UNITED STATES PATENT AND TRADEMARK OFFICE

APPLICATION NO.	FILING DATE	FIRST NAMED INVENTOR	ATTORNEY DOCKET NO.	CONFIRMATION NO.
10/609,038	06/27/2003	Chien-Chung Tseng	MXIC-P910232	8465

Office Action Summary

DETAILED ACTION

FIG. 1

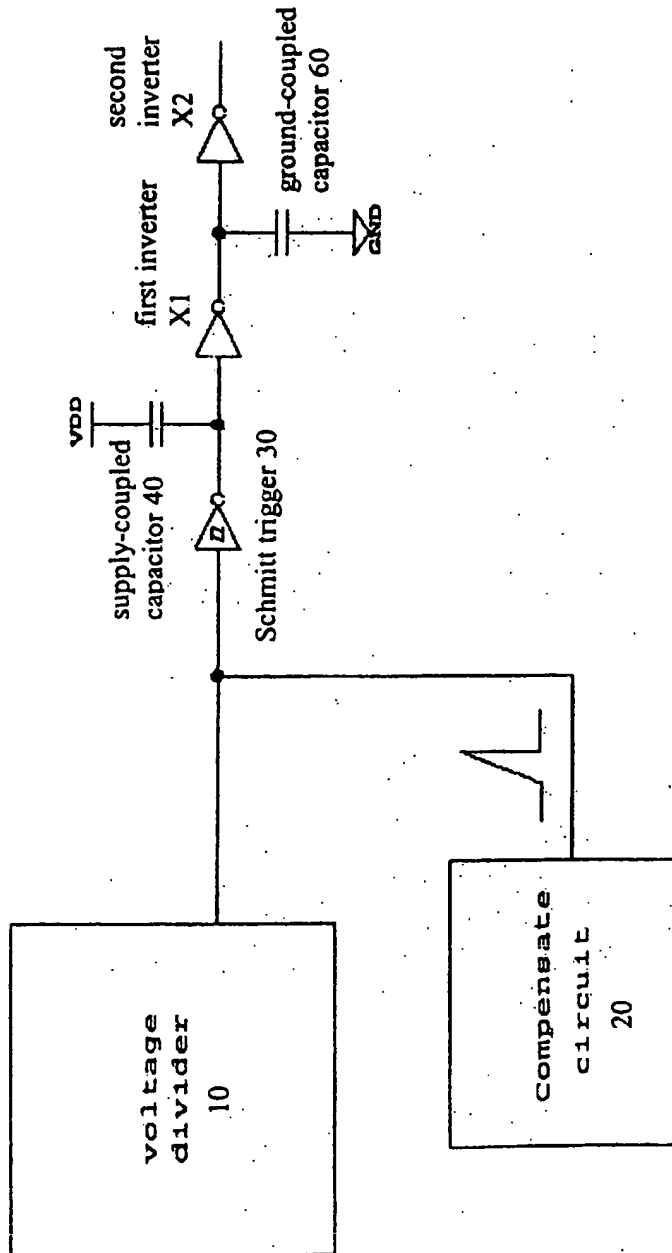
*Figs 1-8B approved
1.20.06
TLE*
